U. S. EPR Standard Design Certification

SRP Section: 09.02.02 - Reactor Auxiliary Cooling Water Systems

09.02.02-114

09.02.02-120

Figure 9.2.2-2—Component Cooling Water System Common Loop 1
Sheet 7 of 7

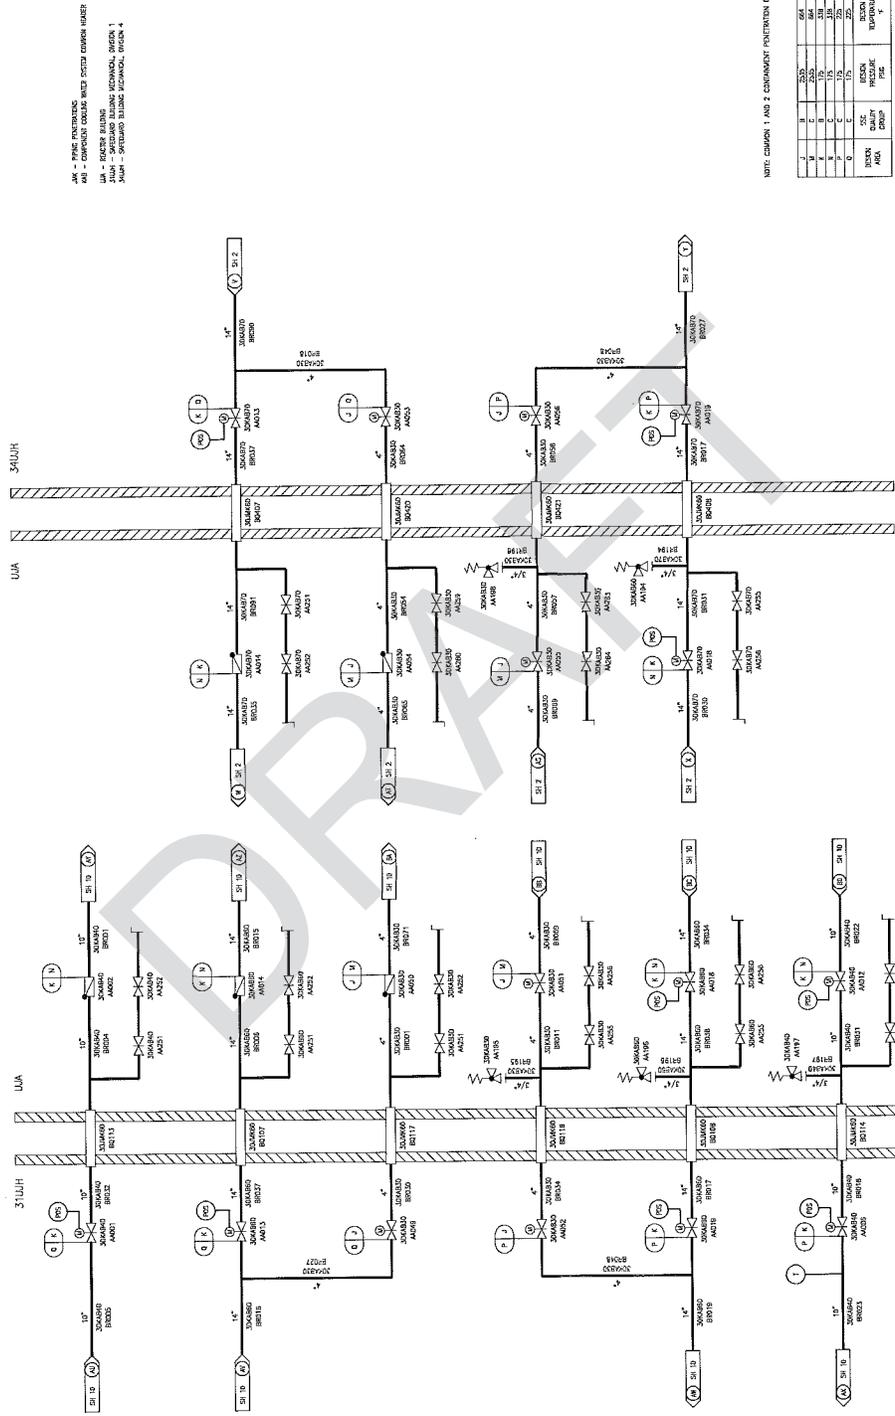
- a. In regard to the discussion in the response about mid position failure of a thermal barrier containment isolation valve (CIV) upon attempting transfer of thermal barrier cooling to the other common header:
 1. Describe the type of actions (and priority) that would be needed if the failure occurred with the valve nearly closed resulting in insufficient cooling to all thermal barriers while still preventing transfer to the other common header, that is, permissive not satisfied. Describe if this is considered a common mode loss of thermal barrier cooling.
 2. Describe in the FSAR the acceptability of taking credit for CVCS seal injection in this scenario when the CVCS is only considered an operational system that may not be present in post accident conditions.

3. Describe in the FSAR if the plant design basis requires CCWS thermal barrier cooling to be functional in post accident conditions (besides during all plant operating modes when the RCPs are running).

4. The applicant's response stated that failure of a CCWS CIV to fully close does not place the plant in a four hour TS action statement to close the other CIV in that flowpath but TS 3.6.3 Containment Isolation does apply. The applicant should provide the basis for these conclusions and explain the aspect of TS 3.6.3 that does apply including the applicable LCO duration.

5. Describe in the FSAR if the RCP standstill seal (discussed in the original response) is credited as a safety-related design basis accident mitigation feature or is it intended only for conditions that are beyond the normal design basis.

U.S. EPR FSAR Tier 2, Sections 9.2.2 and 14.2 and Tier 1 Section 2.7.1 will be revised as described in the response and indicated on the enclosed markup.
